A100F RECEIVER SUPPLEMENTARY SERVICE INSTRUCTIONS

For use in conjunction with A100 Service Instructions

SUBJECT TO ALTERATION WITHOUT NOTICE ISSUE B

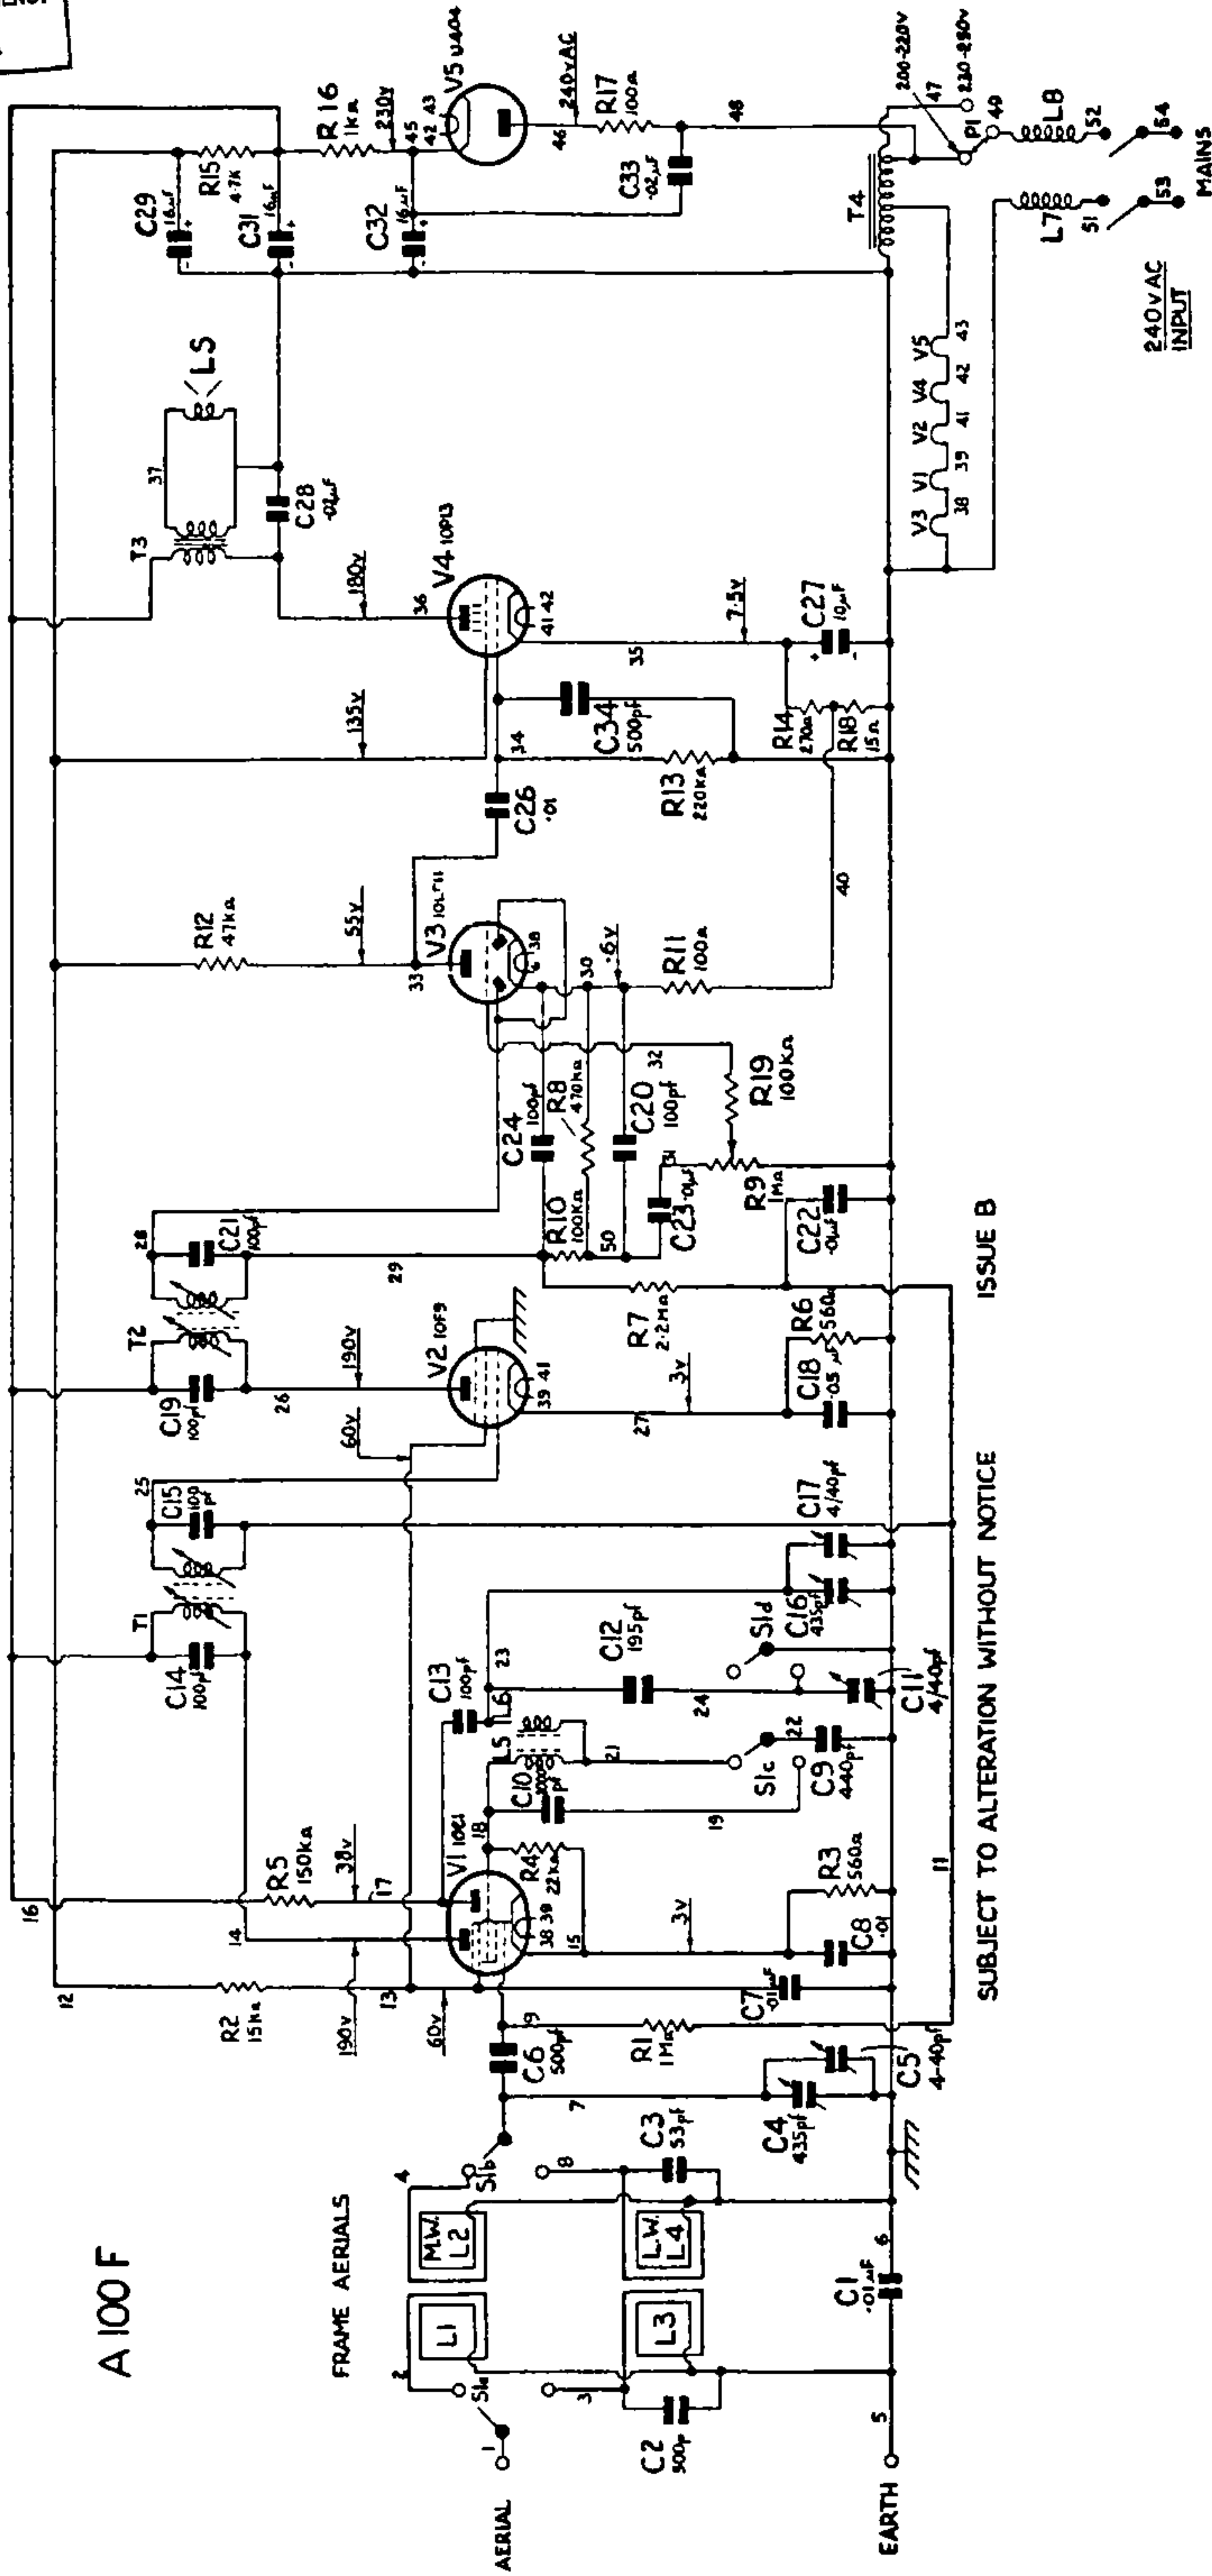
Approximate resistances of changed and additional coils:

M.W. Frame Aerial, coupling (L1) approx. one ohm, tuned winding (L2) less than one ohm, L.W. Frame Aerial, coupling coil (L3) 35 ohms, tuned winding (L4) 20 ohms; Mains Filter Coils (L7 and L8) 5.7 ohms each.
